Subject: Request for Modification to Individual Section 404 Permit and Section 401 Water Quality Certification for U-2579 AA and AB, the Winston-Salem Northern Beltway (Eastern Section of Future I-74), from US 311 to I-40; Federal Aid Project No. NHF-0918(14), Division 9. Debit \$570 from WBS No. 34839.3.GV5.

The purposes of this modification are as follows:

PERMIT DRAWING SHEET 7 OF 78

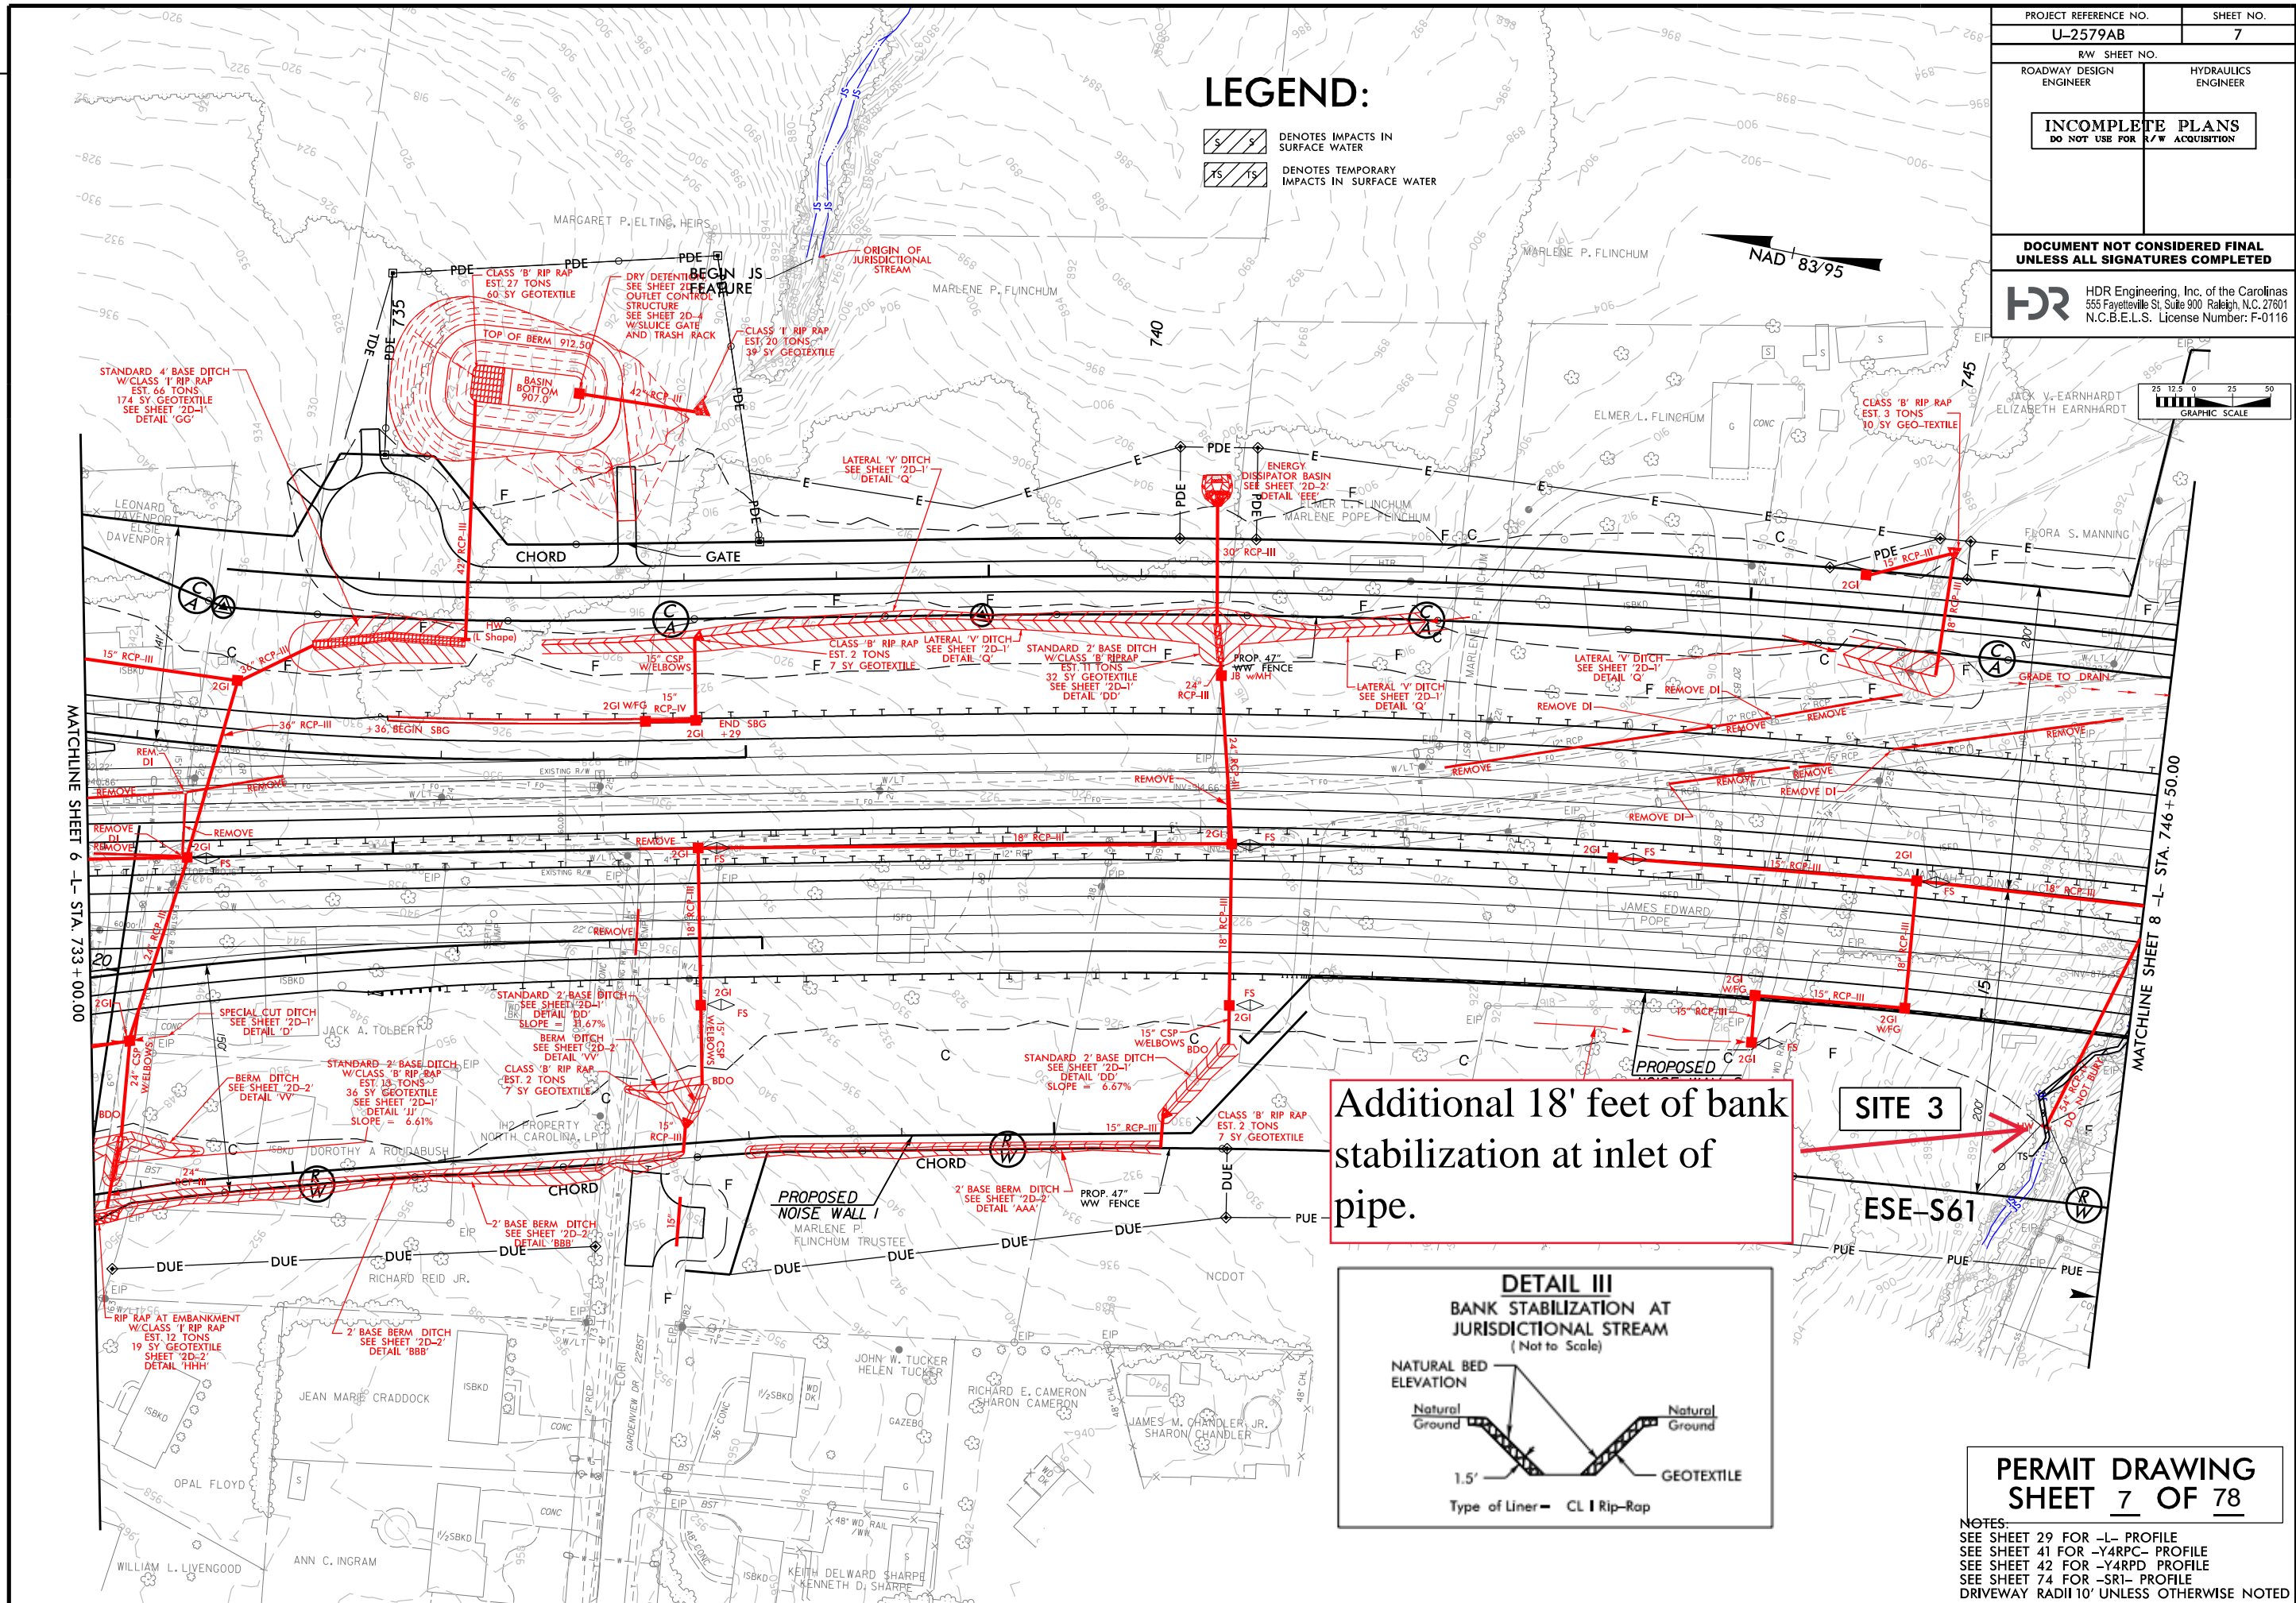
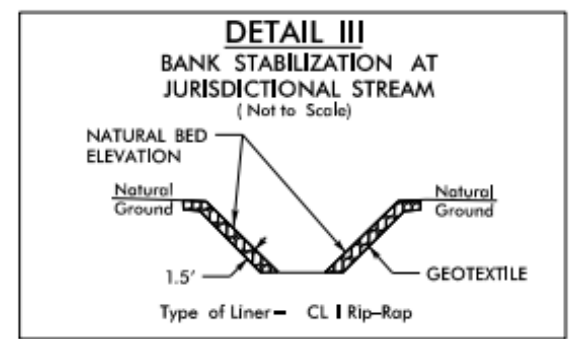
1. To account for 18’ linear feet of permanent bank stabilization impacts at permit site 3 on the U-2579AB project. The permanent impacts overlap with the previously permitted 12’ of temporary impacts at site 3. See table 1.

Additional 18' feet of bank stabilization at inlet of pipe.

Site 12A/12B revision: note relocated dissipater. no changes in stream impact length or loss of water impacts

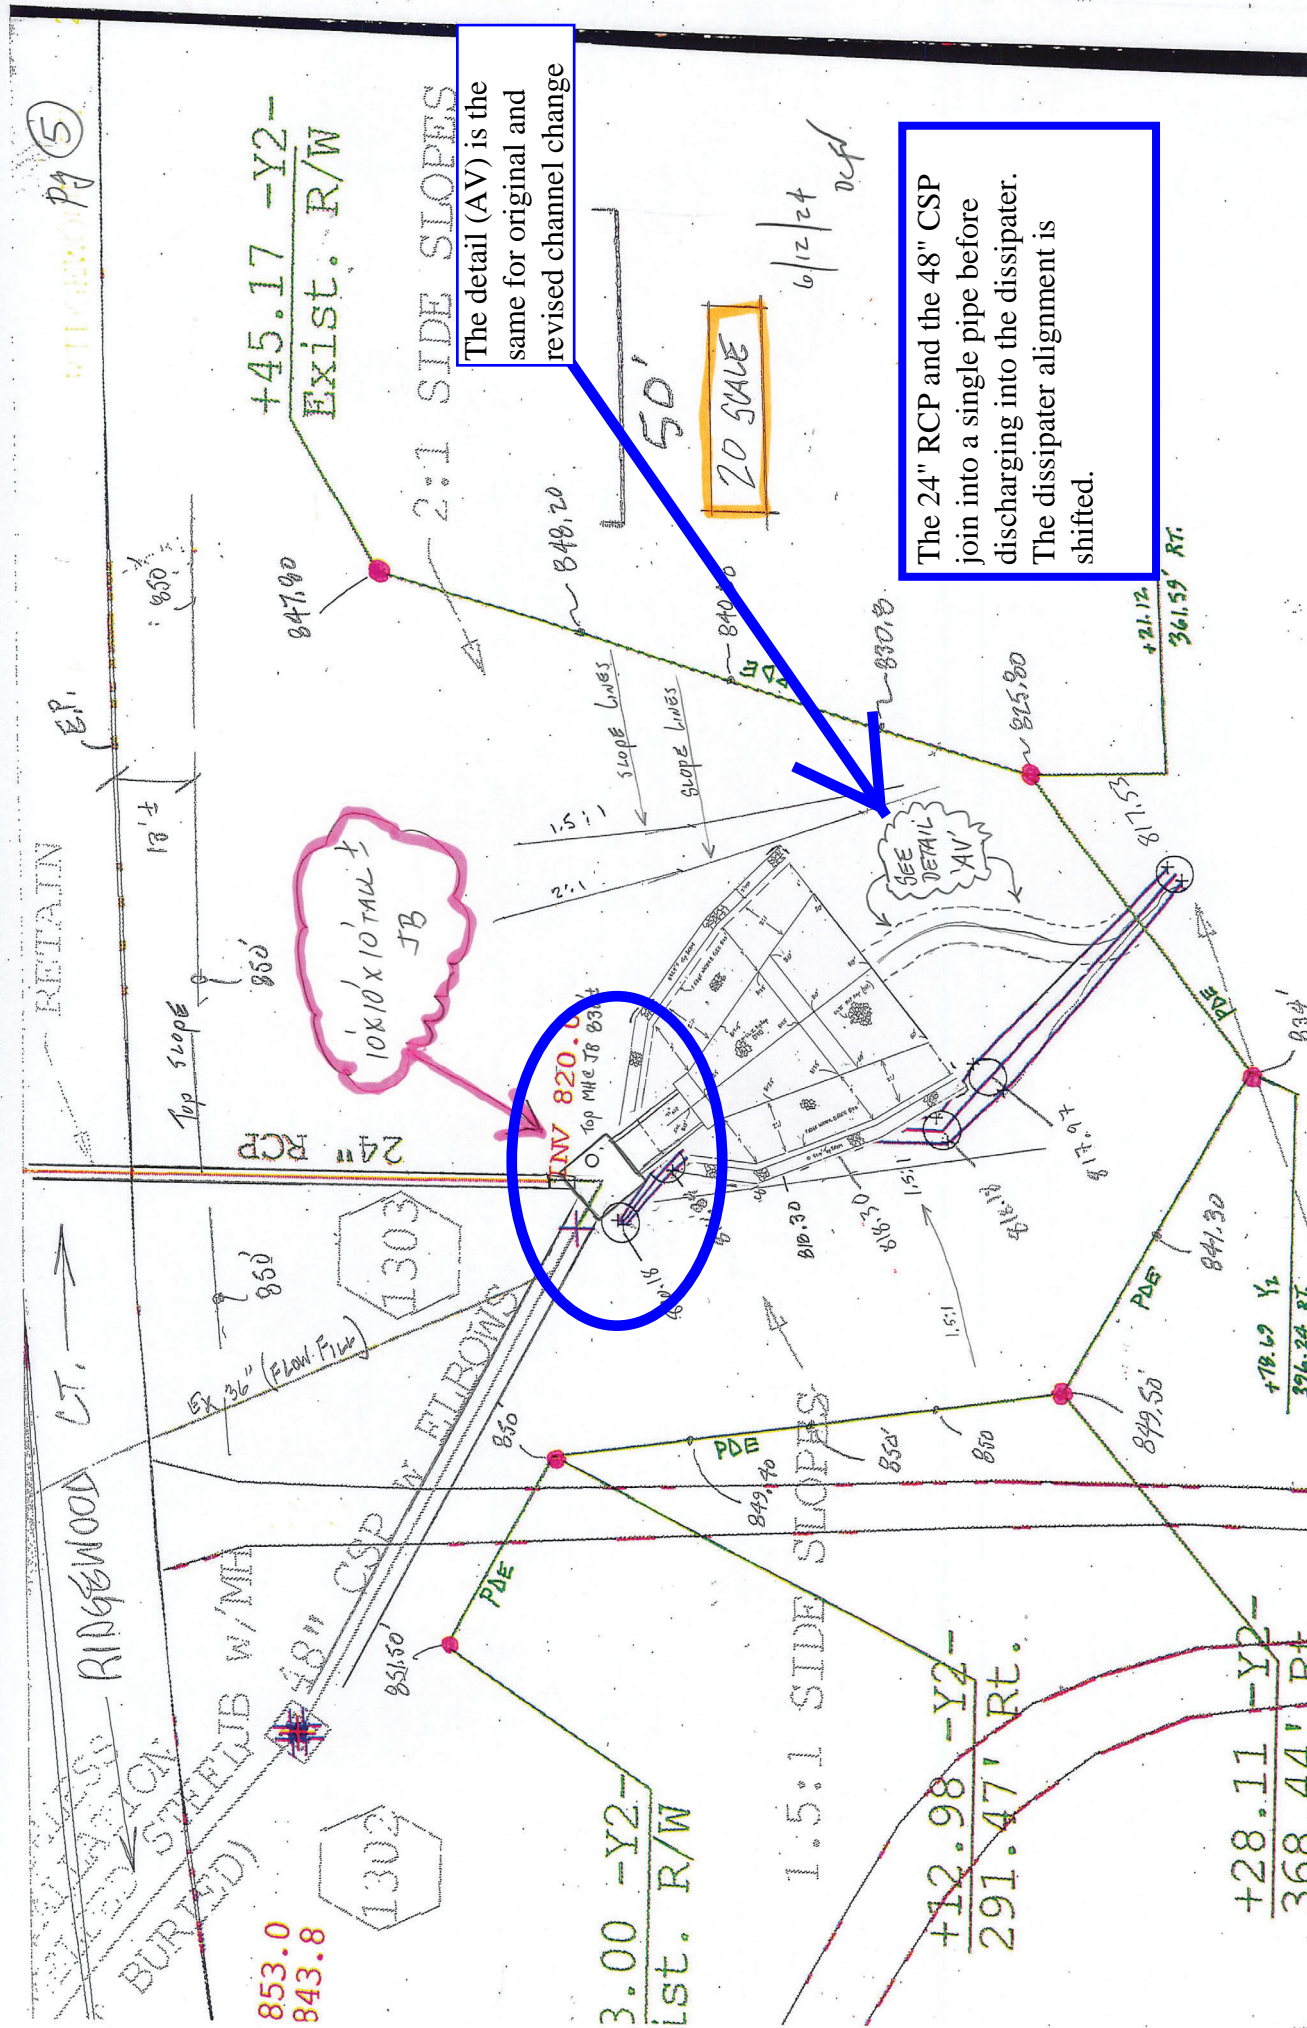
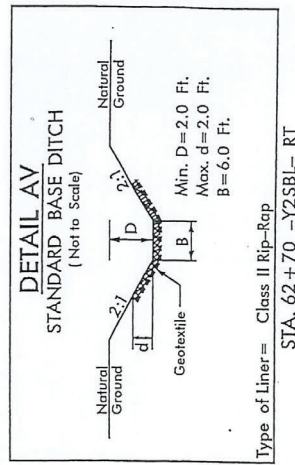
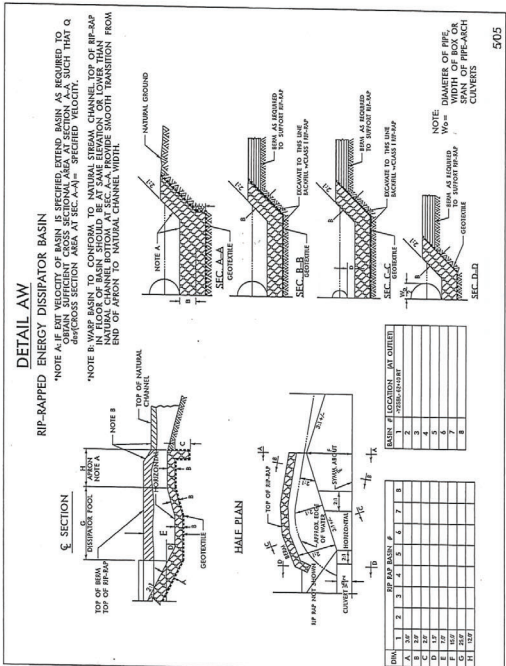
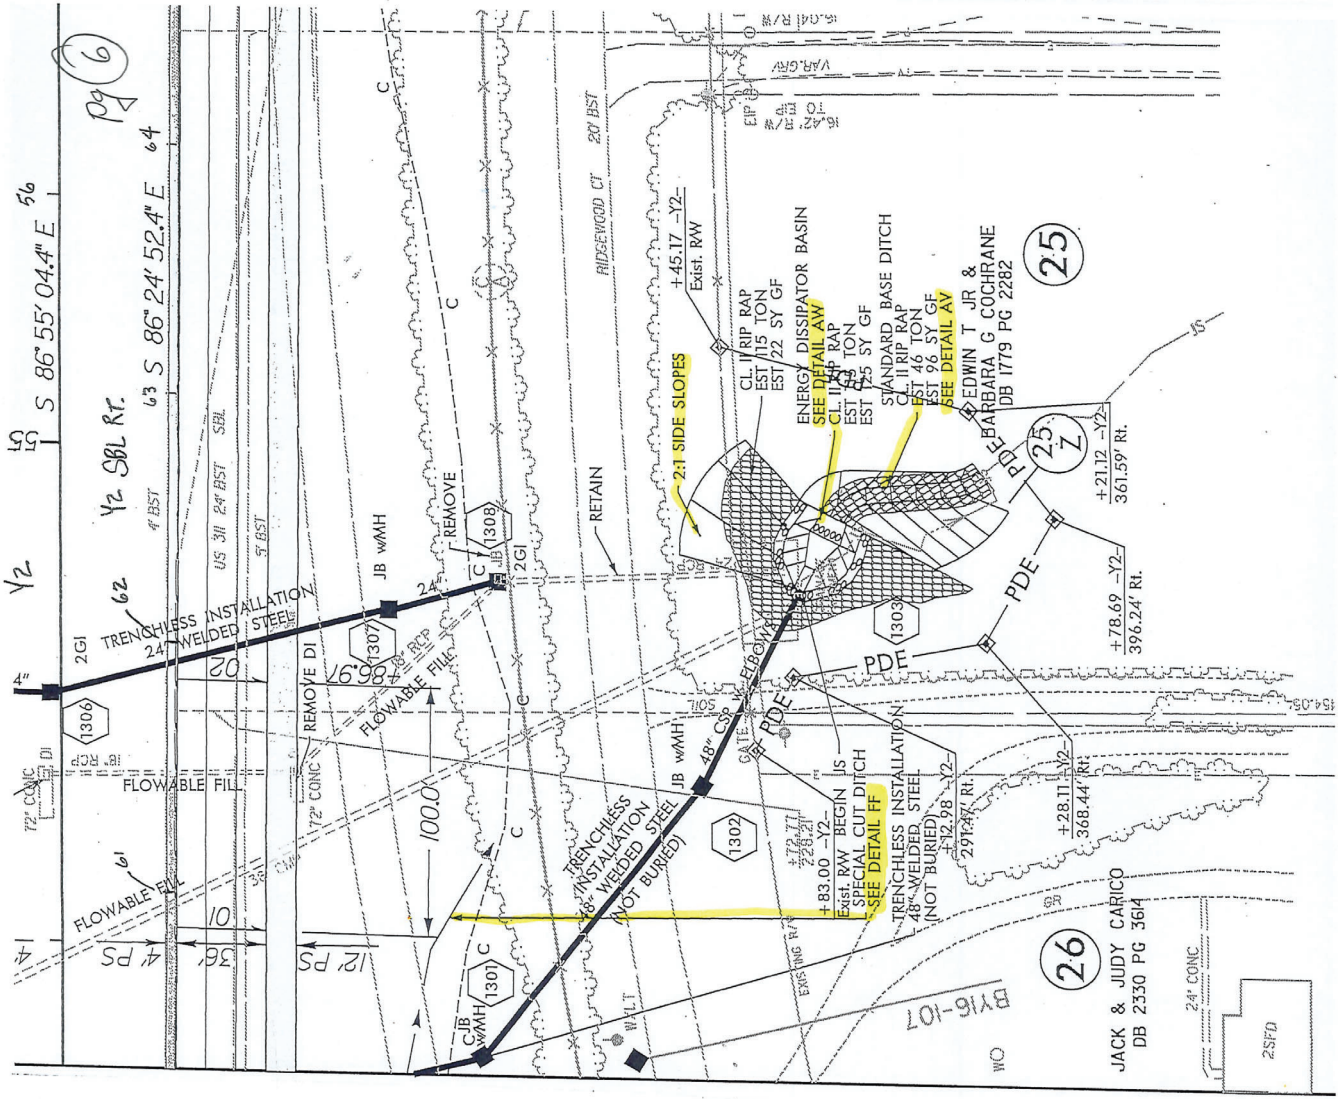
2. We also have changes to the permit plans on U-2579AA with no changes to the permit impact numbers. The changes are summarized as follows:
 - a. Permits sites 12A and 12B: The 24" RCP and the 48" CSP join into a single pipe before discharging into the dissipater. The dissipater alignment is shifted.
